Metro 78 (LDA20-0066)

(Dec 6, Public Hearing)

Agenda items 3.25-3.28

Metro78 West buffer- *purpose and value*

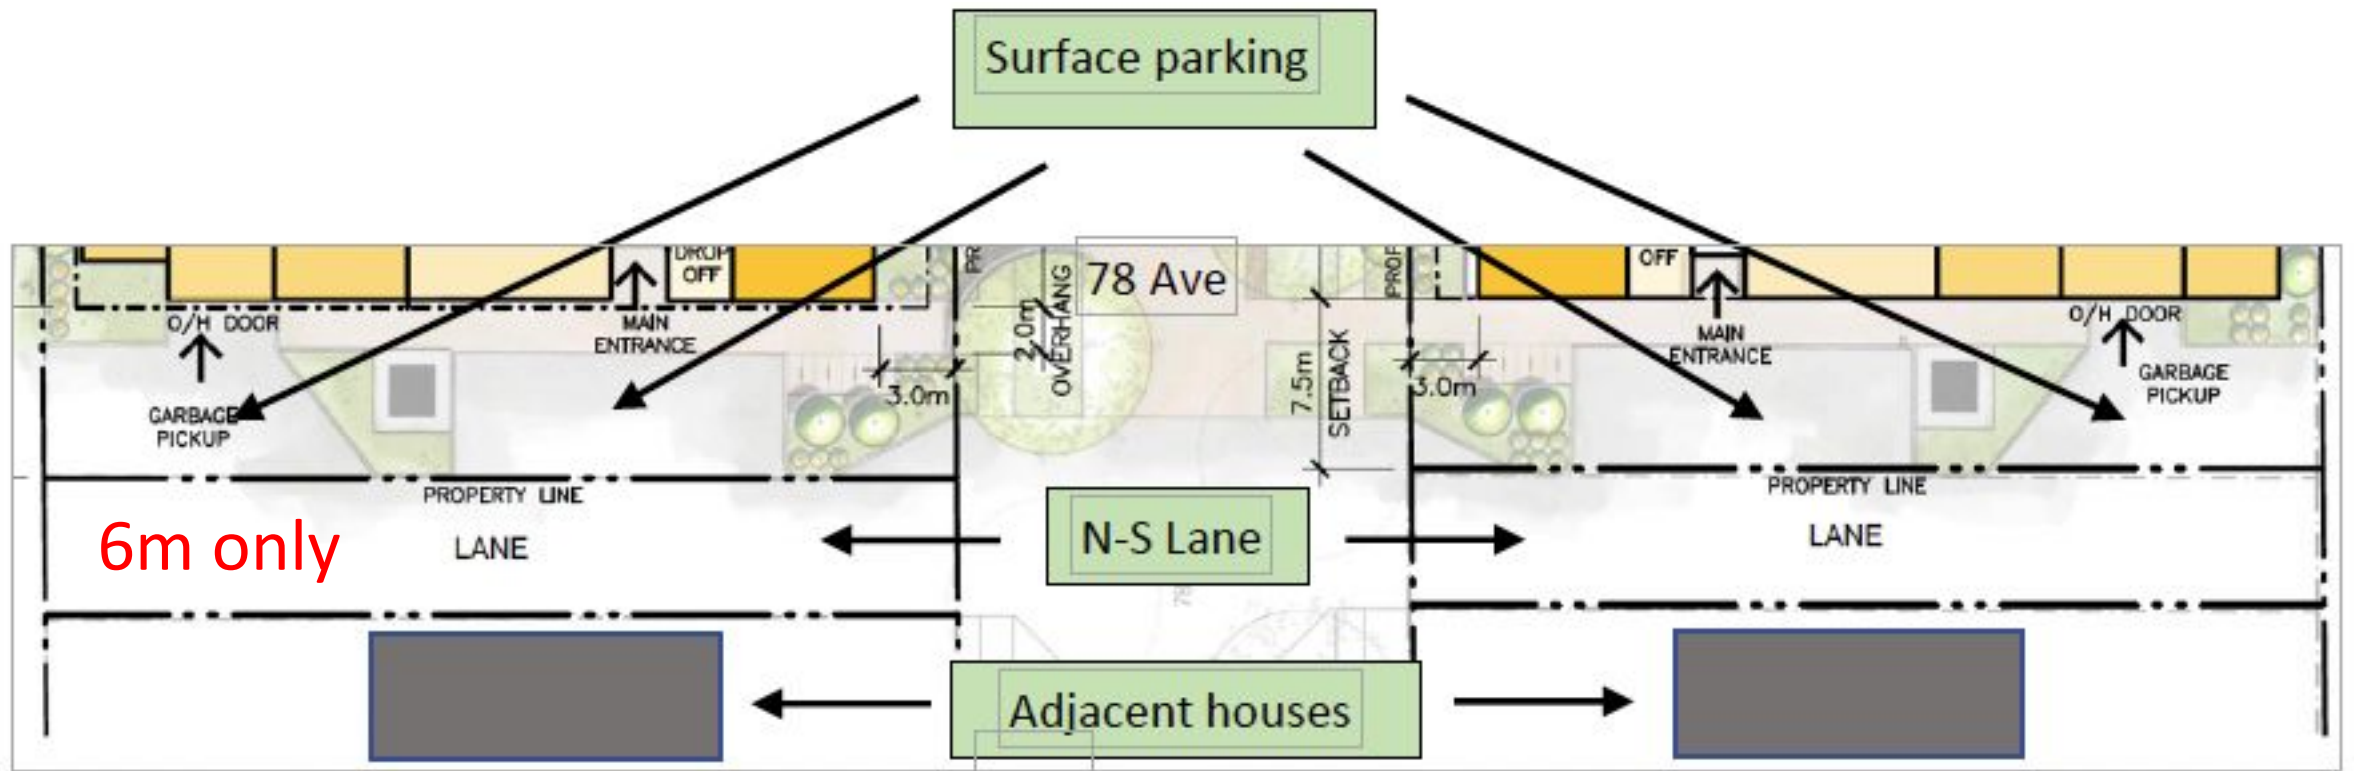
The Metro 78 proposal requires a new N-S lane to be built between 'the development' and the adjacent single detached homes on the west.

It has purpose and value:

- **General vehicle access.** It will connect 78 Ave with the east and west back lanes to allow vehicles access to 115 St
- **Drive-aisle.** Provide access to the Metro 78 surface parking lot.
- **Emergency vehicle access.** Access for emergency vehicles.
- **Sufficient clearance from adjacent homes** (noise, damage, pollution from vehicles to fresh airtakes)

Metro78 West buffer- *does NOT meet standards*

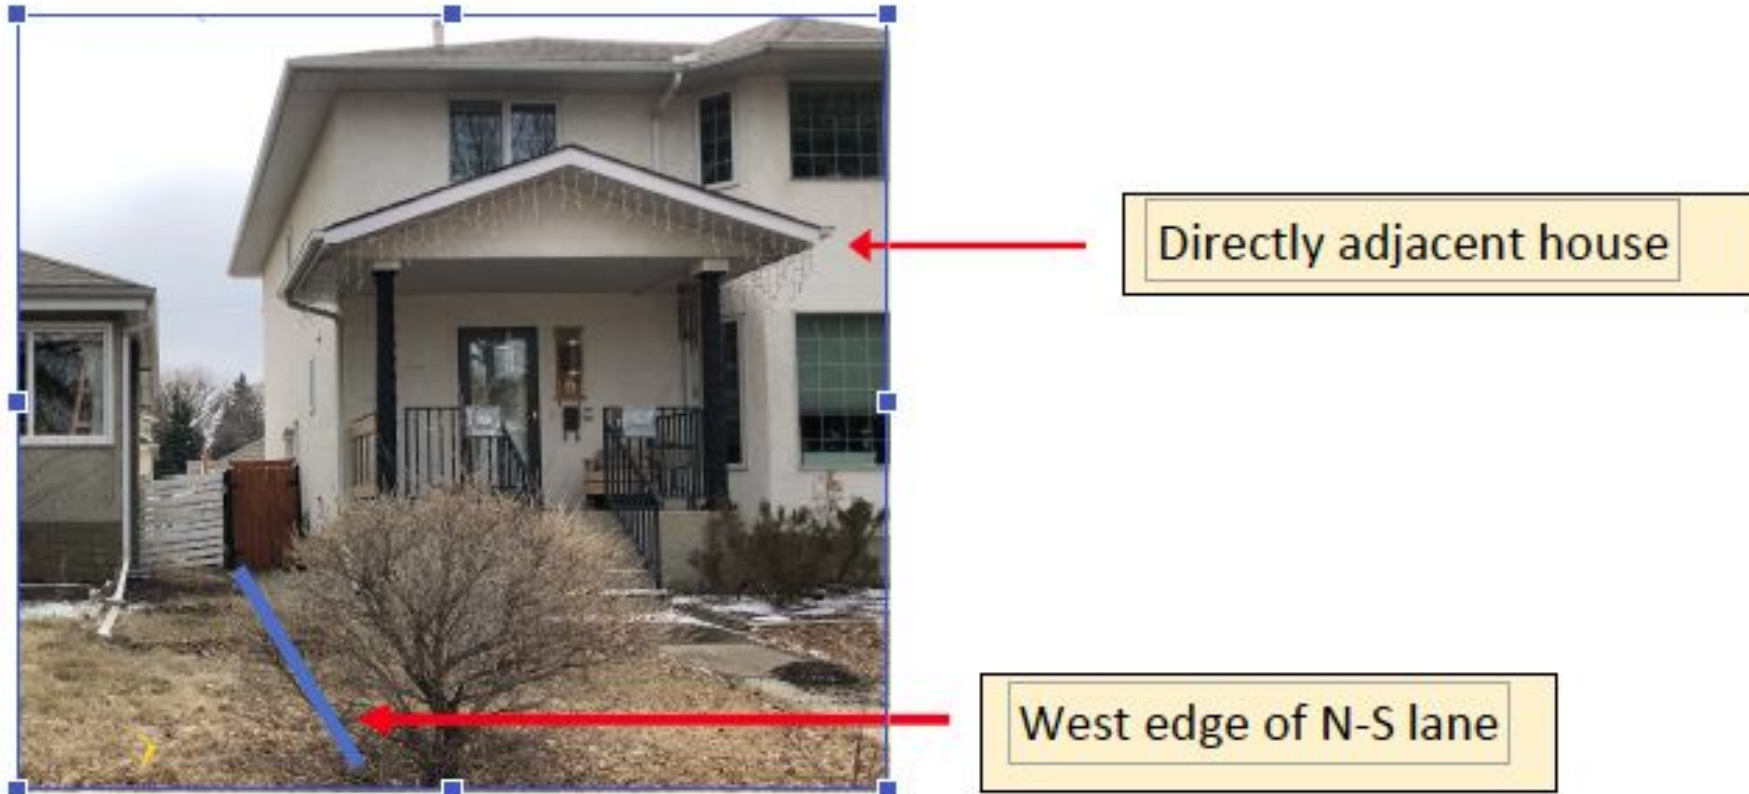
City Design Standards indicate 7.5m for this type of back lane (reverse back lane) to allow for fire trucks (Section 3.9 pg. 170).

City Zoning indicates the drive aisle for a surface parking lot should be 7m (54.1.6.c).

Current design has the N-S lane as 6m- without any justification?

Proximity of adjacent housing to N-S lane is a concern for noise, damage, pollution from vehicles to fresh airtake(s).

Provide a minimum 1m landscape buffer between the N-S lane and adjacent west homes (bring the lane to 7.5m). This will not substantially change the build form and allow for the development to meet standards and be conscious of the surrounding community.
